*Report for a Constructability Review
& a Value Engineering Study
For the Issaquah School District*

ISSAQUAH
SCHOOL DISTRICT 411

For Elementary School No. 15

May, 2009

VE PROPOSAL No. 1: IDEA No. 13 Consider the use of conventional asphalt paving and eliminating the permeable paving section since all of the existing storm water is being injected into the ground on-site.

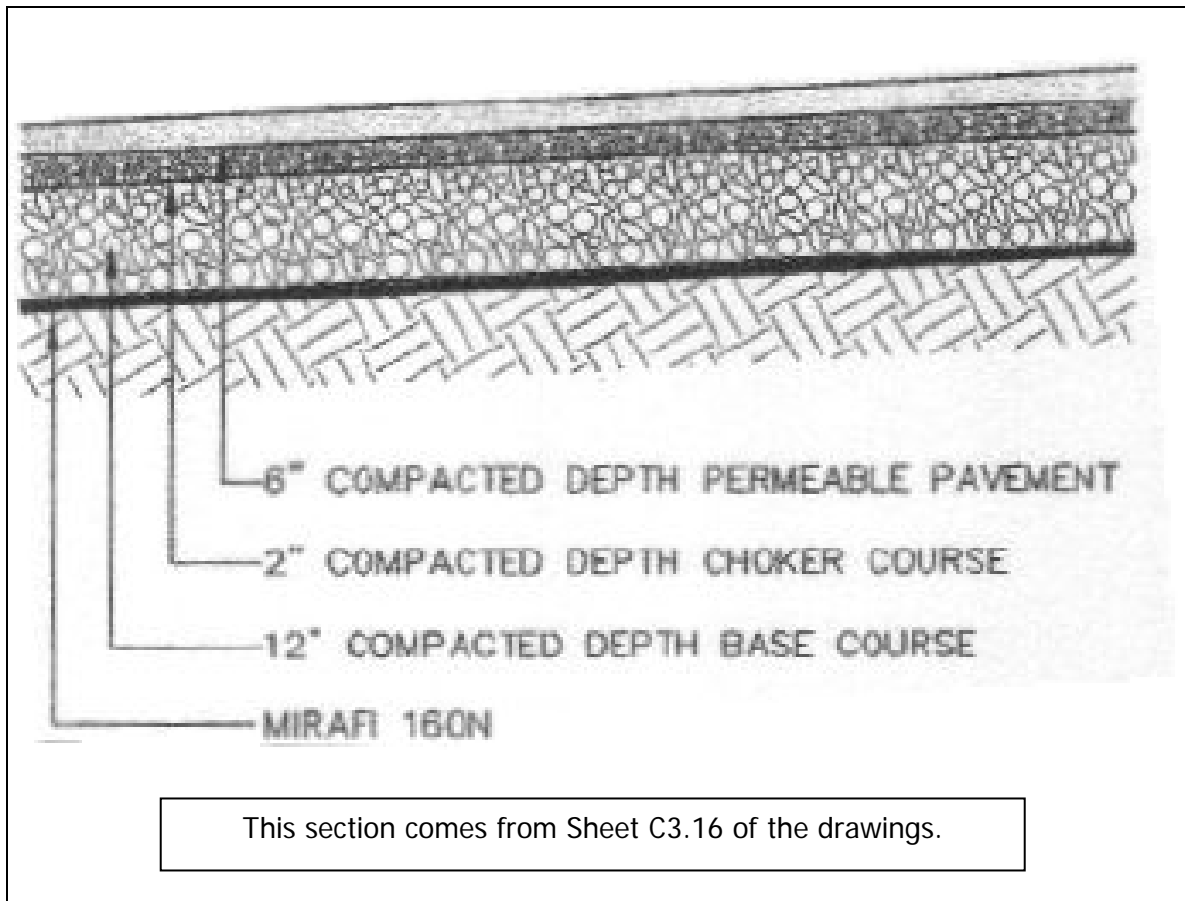
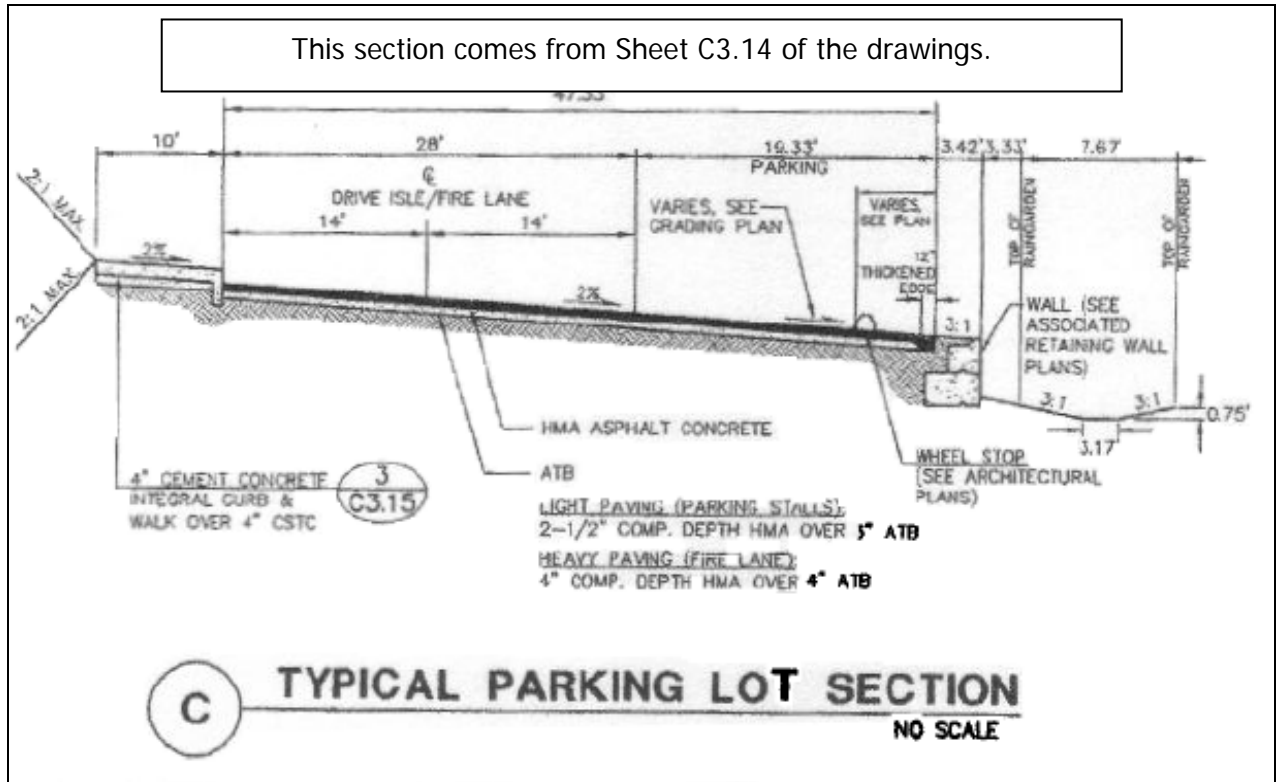
This proposal suggests replacement of the pervious asphalt mat on with conventional asphalt concrete. For analysis of the proposal, the pavement cross section selected is the same section proposed in the contract documents for the parking area in front of the school building. The area selected for this VE Proposal is shown on Sheet 3.01, which is not included in this report.

VE PROPOSAL No. 2: Idea No. 70 Delete the temporary ATB pavement

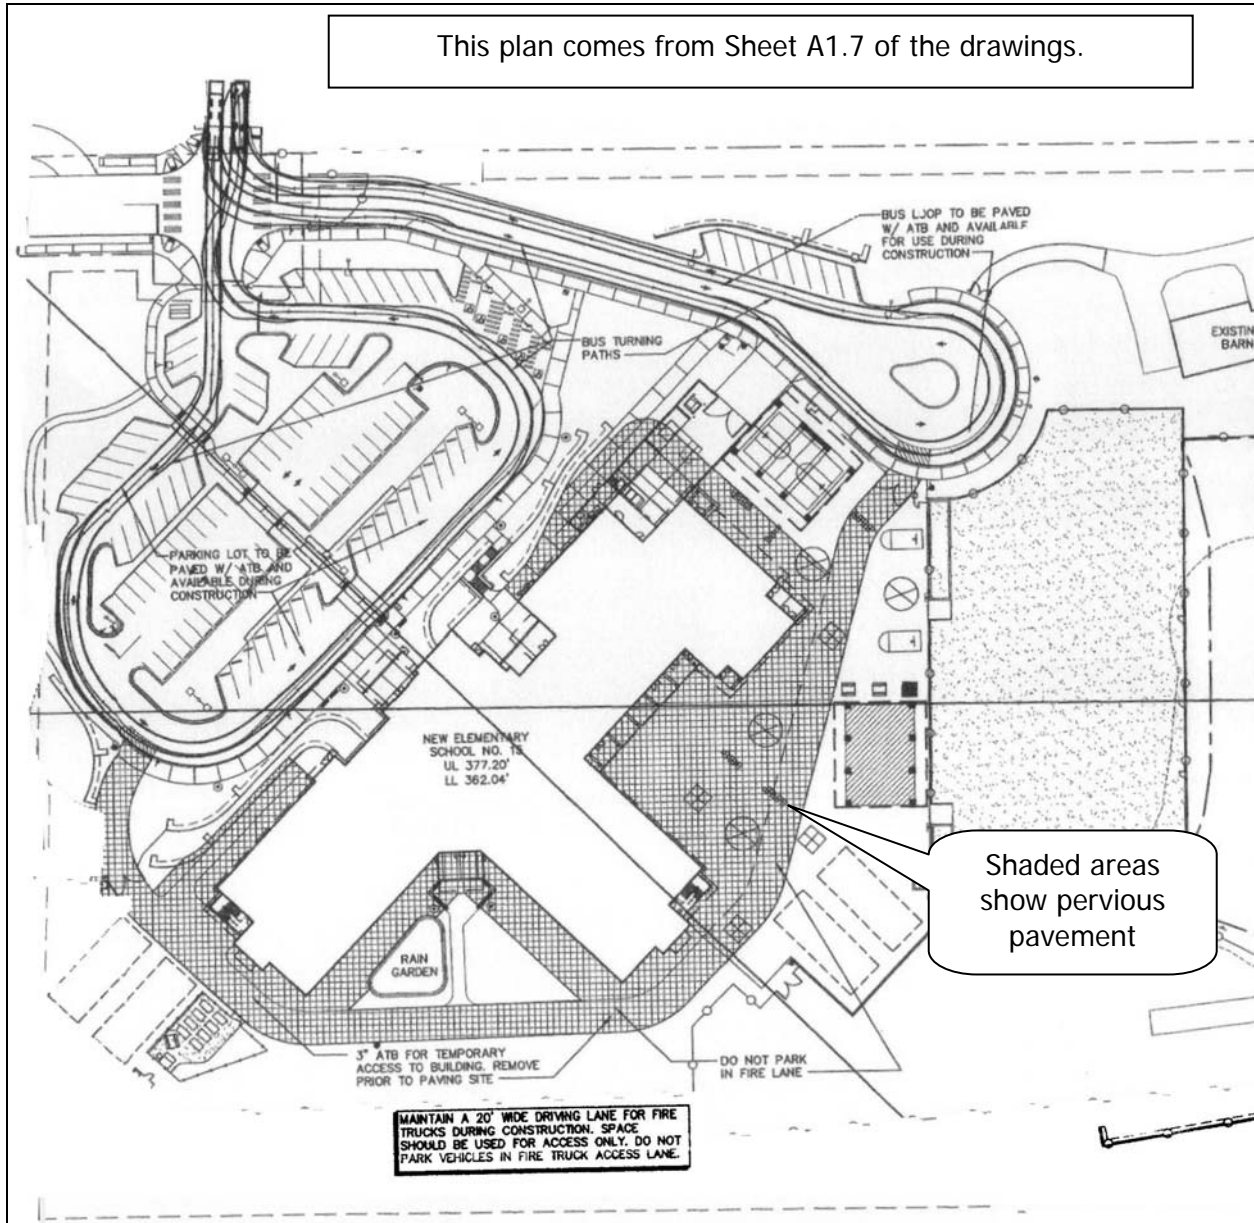
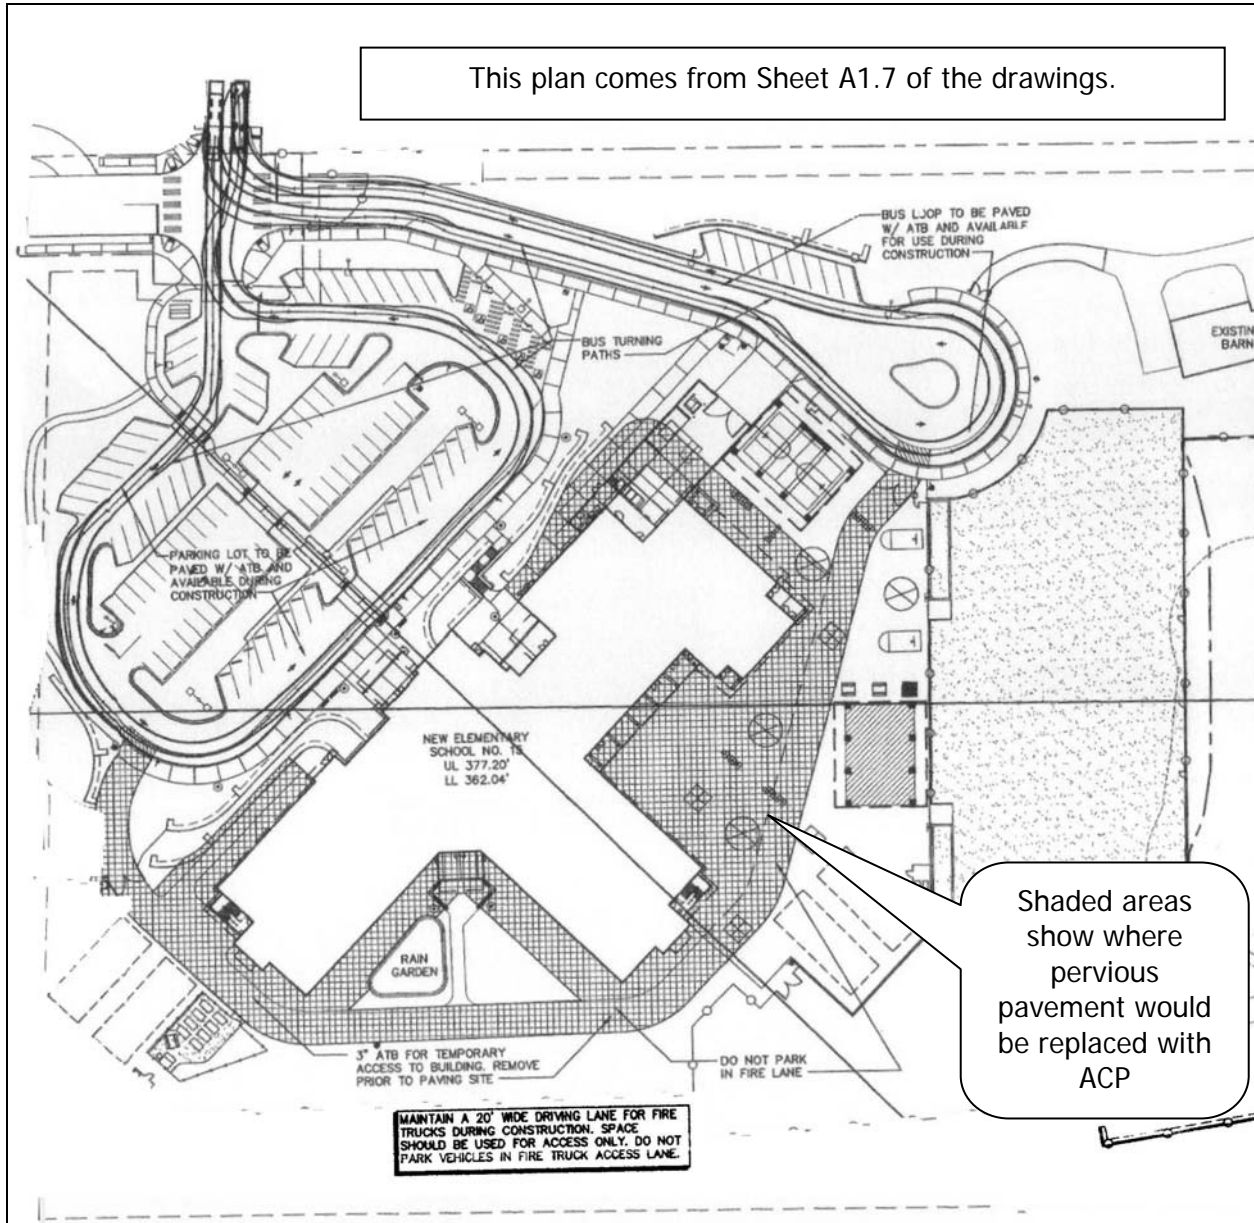
The design element selected for study is the temporary asphalt concrete mat specified in the design documents.

This proposal suggests replacement of the pervious asphalt mat on with conventional asphalt concrete. For analysis of the proposal, the pavement cross section selected is the same section proposed in the contract documents for the parking area in front of the school building. The area selected for this VE Proposal is shown on Sheet 3.01, which is not included in this report.

VE PROPOSAL NO. 3: IDEA NO. 14 - Consider using drought resistant plantings without irrigation in the garden areas in order to reduce irrigation system to a temporary "two year" starter system and only permanently irrigate the lawn areas.

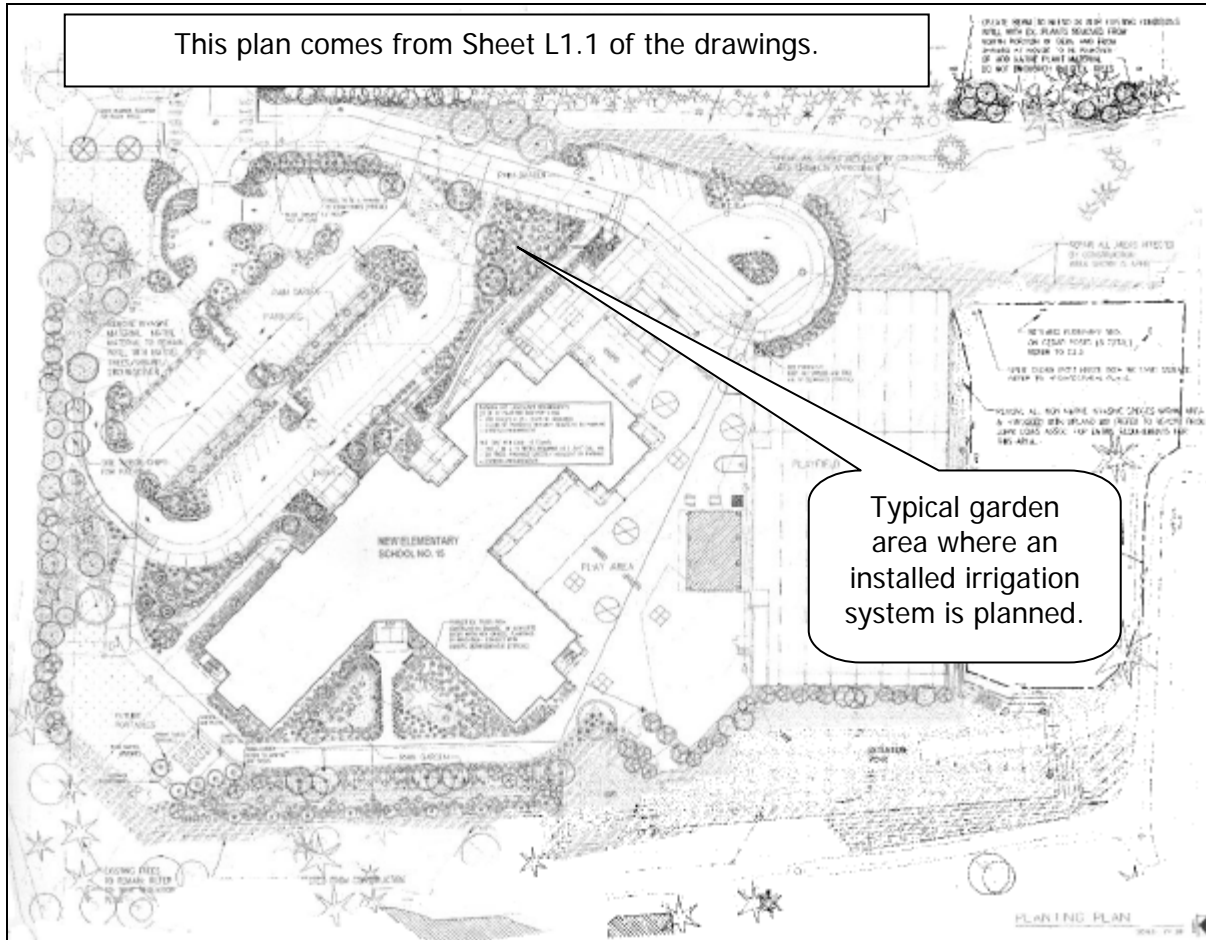
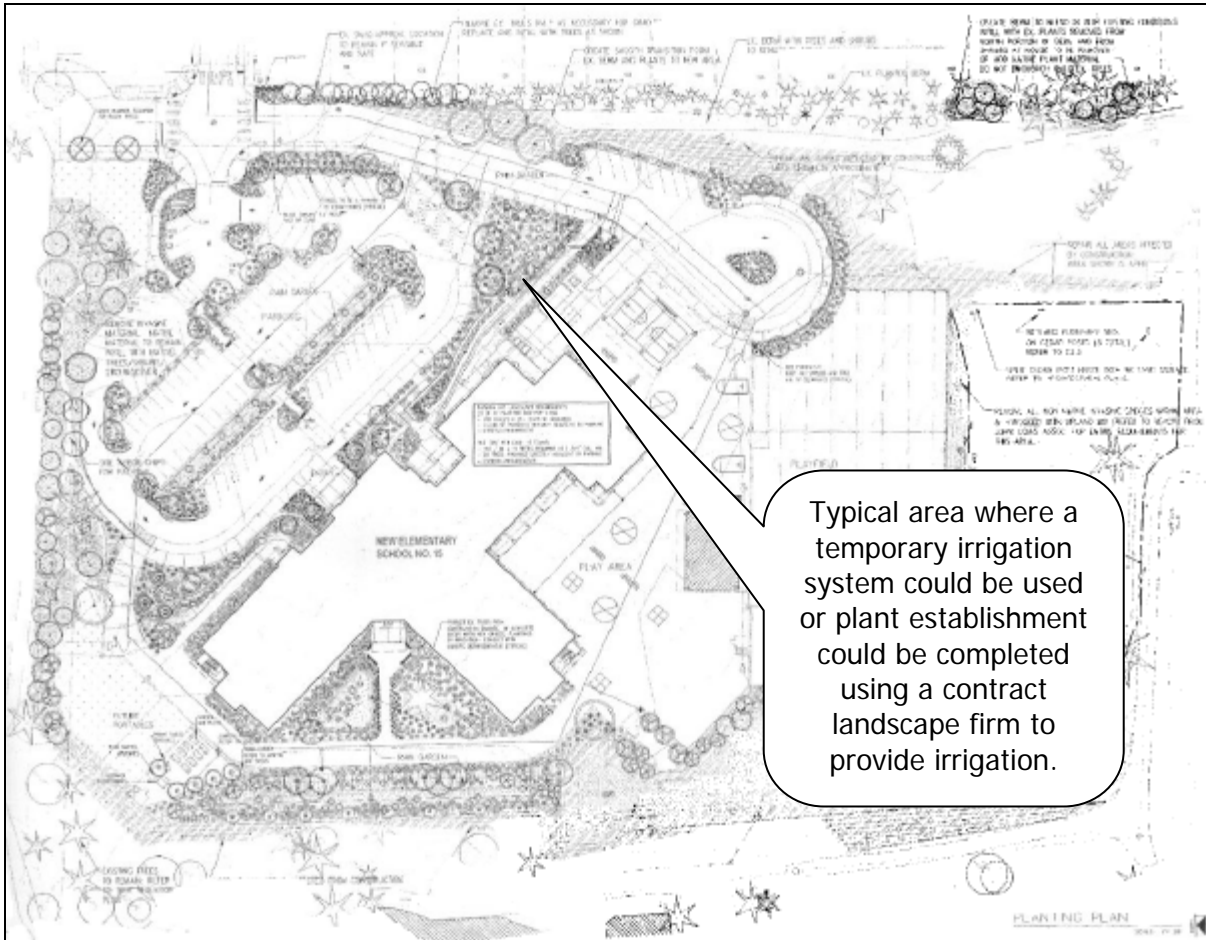
The design now shows a permanent irrigation system that is planned for the garden areas of the site. This is a typical design for many facilities.

The design element selected for study is the permanent irrigation system that is planned for the garden areas of the site. Some owners have found that the use of drought tolerant plantings with a irrigation system that is planned only for temporary use can provide a more desirable outcome after the two year plant establishment period with less capital cost. There should be no increase in the operations and maintenance cost for this proposal. The plant establishment period can have irrigation supplied by a temporary irrigation system installed in the garden areas or by the use of a "contract maintenance" landscaper. The City of Bothell uses a contract landscaper to establish plantings. That landscaper uses a water truck to supply irrigation water to the plants on a regular. Then there is no temporary irrigation system at the end of the two year period to remove.

VE PROPOSAL NO. 4: IDEA NO. 73 - Redesign the shrub beds to utilize draught tolerant plants without an installed irrigation system.

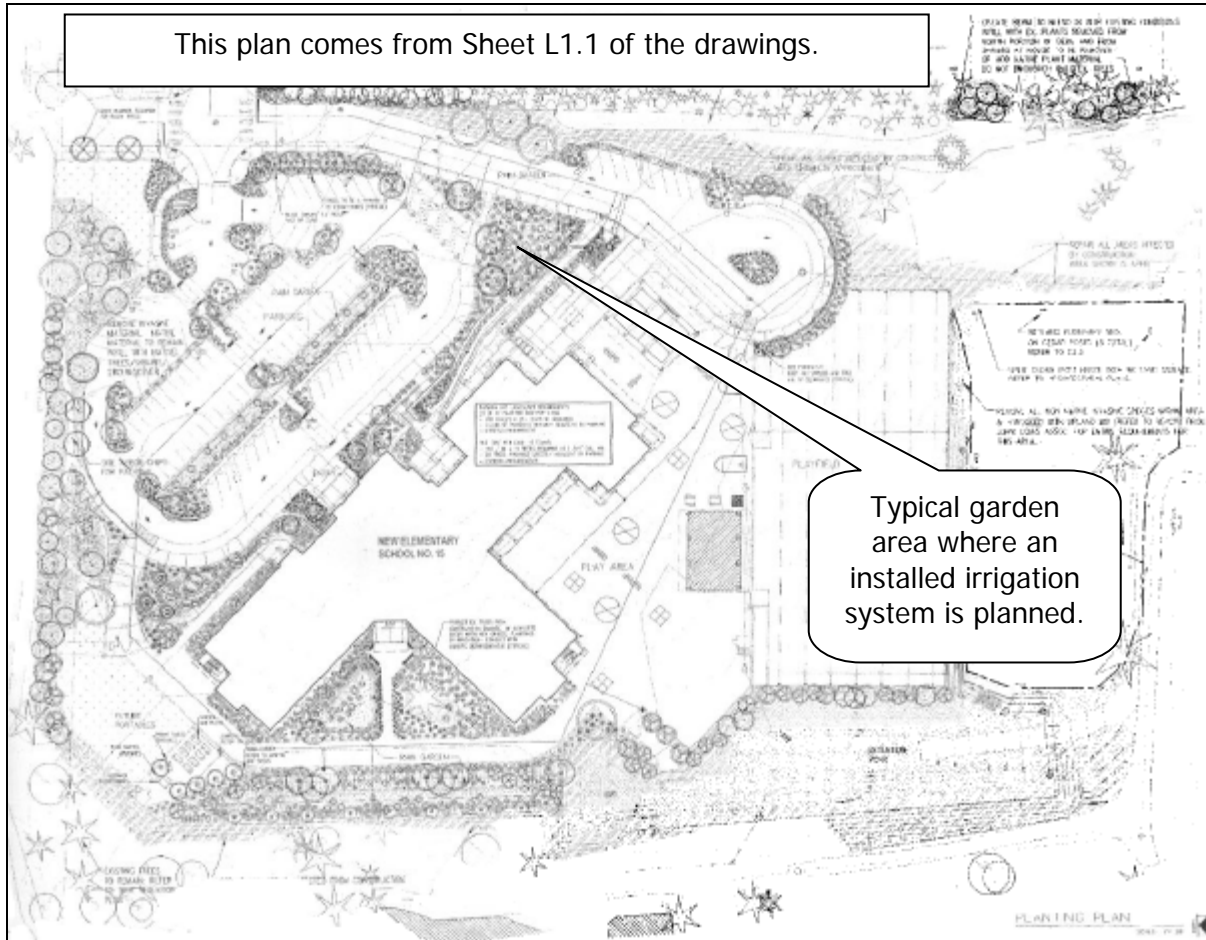
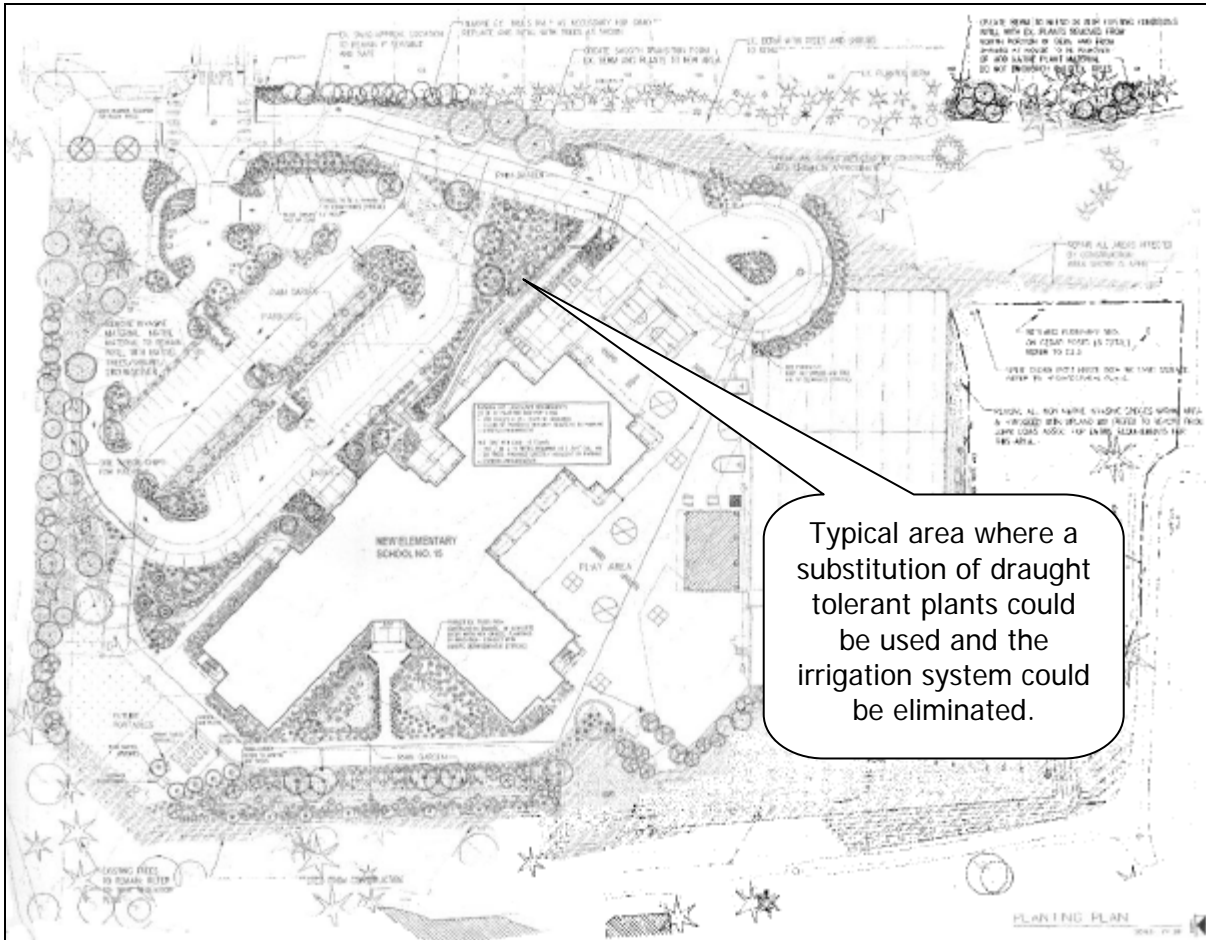
The design now shows a permanent irrigation system that is planned for the garden areas of the site. This is a typical design for many facilities.

The design element selected for study is the permanent irrigation system that is planned for the garden areas of the site. Some owners have found that the use of drought tolerant plantings can provide an acceptable solution that also shows the community a consideration for conservation of resources with regard to the amount of plantings and the requisite maintenance associated with a conventional irrigation system. This proposal is similar to VE Proposal No. 3, but it totally eliminates the irrigation and reduces the amount of plantings. Maintenance costs have been maintained at the same amount as VE Proposal No. 3, and there may be an opportunity for greater life-cycle savings.
